Redpoint Jackets Ltd

Dhaka Export Processing Zone, Ganakbari, Savar, Dhaka
(+23.7514N, 90.3917E)

Survey Observations

Steel roof to 2nd floor store

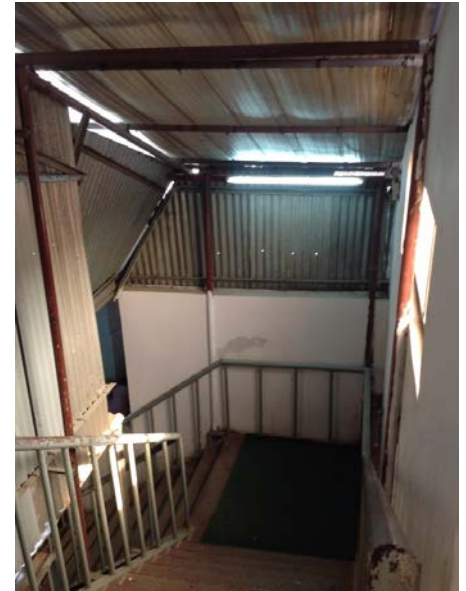
Steel roofs to dining and store area on 2nd floor do not appear to be strong enough to resist high wind loading

**Secondary roof structures, comprising metal deck/purlins and columns, not shown on the structural design drawings, may be susceptible to wind uplift.
No obvious stability system is evident.**

Lightweight roof steel structure not shown on the structural design drawings

Cantilever section of truss to be reviewed by Building Engineer

- Steel roofs to dining and store area should be designed by the Building Engineer and, if required, upgraded to support code vertical and wind loads or they should be vacated and removed

3rd Floor - Lightweight steel roof

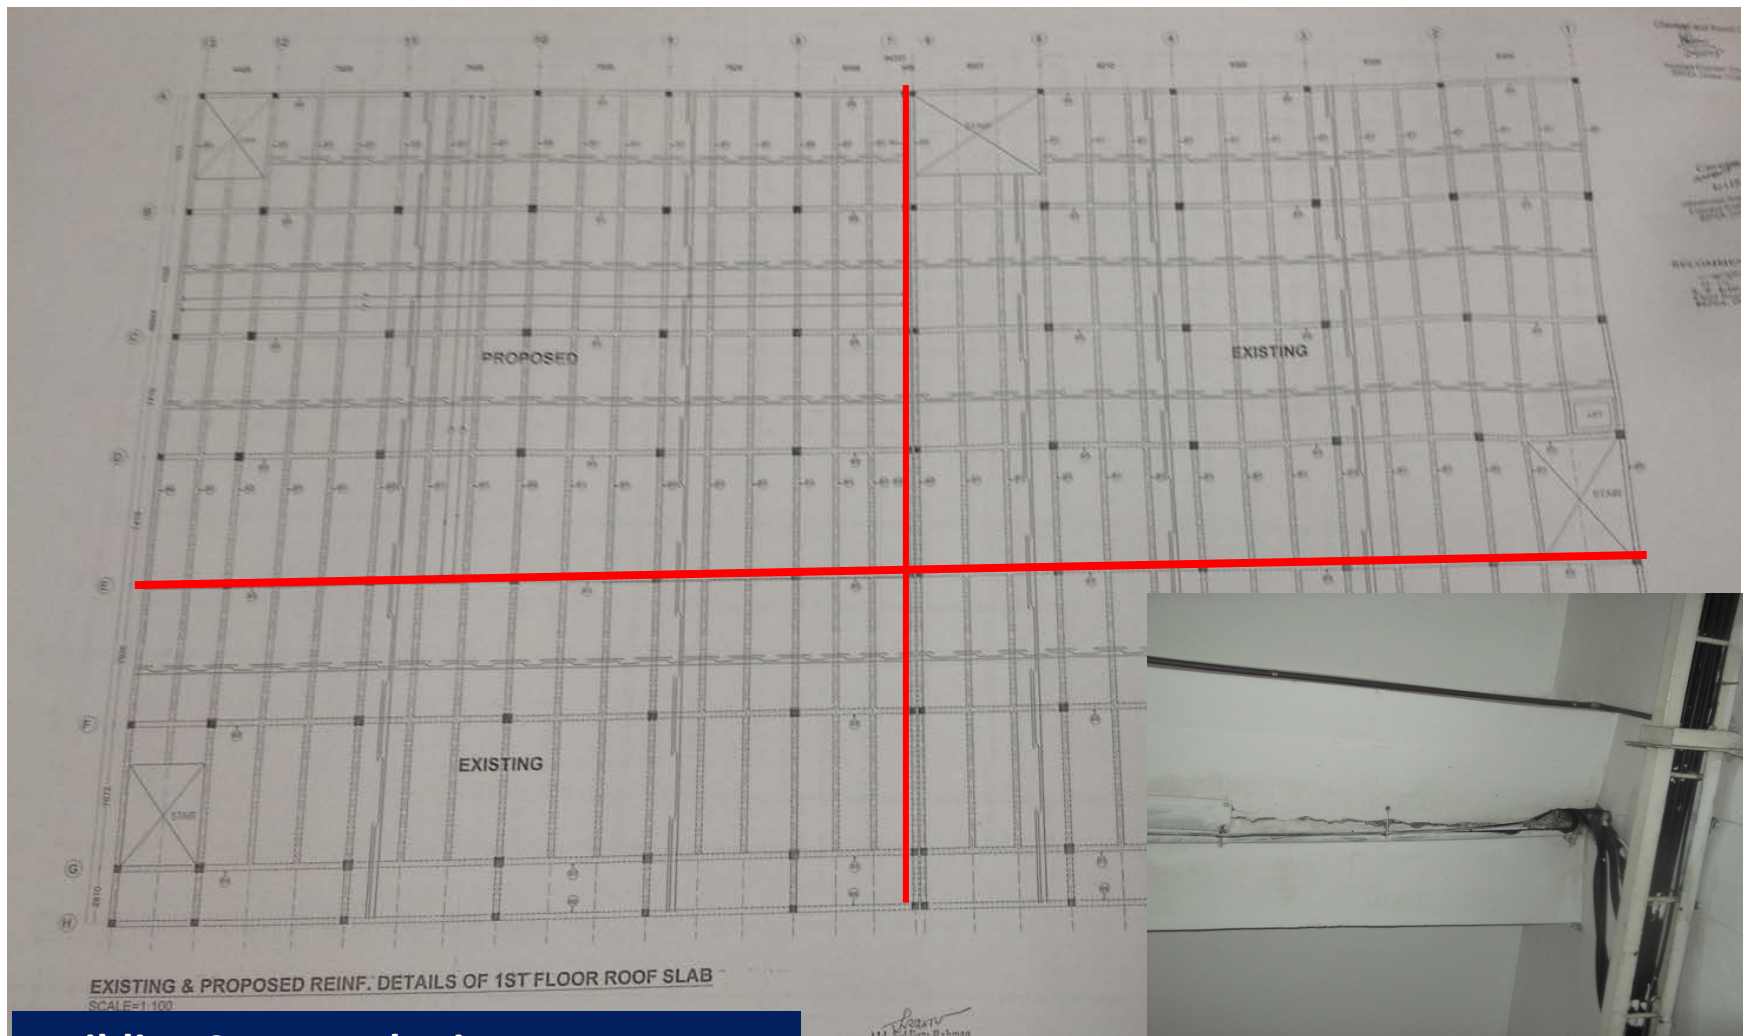
**Check required to confirm that steel roof
over 3rd floor factory area is designed to
resist high wind loading**

Lightweight roof steel structure to the 3rd floor factory area is not shown on the structural design drawings.

Limited access was available for inspection by removing ceiling tiles locally.

Building Engineer to confirm that steel roof has been designed for code specified wind and live loads and that a stability bracing system has been provided.

- The steel roof over the 3rd floor factory area should be designed by the Building Engineer and, if required, upgraded to support code vertical and wind loads or they should be vacated and removed.

**Building constructed in different
phases**

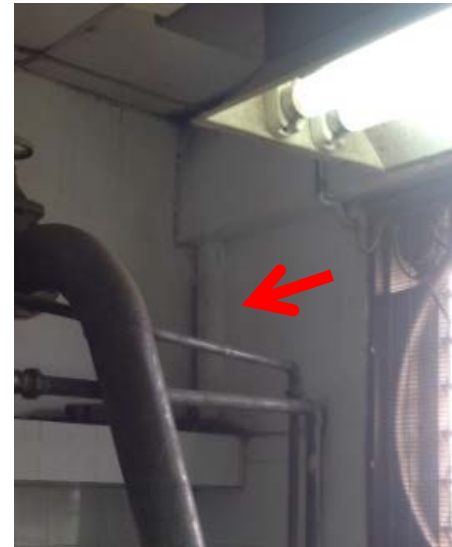
Level difference between floor slabs constructed during the different phases of construction

**Building Structural Joints –
Between different phases of
construction**

**Evidence of movement on
underside of structural joint**

- Building Engineer to carry out on-going monitoring of floor slab levels along the line of the two construction joints at each floor level to confirm that no relative movement is now taking place and that the current level difference is associated with an error in the alignment of the floor slabs at construction.
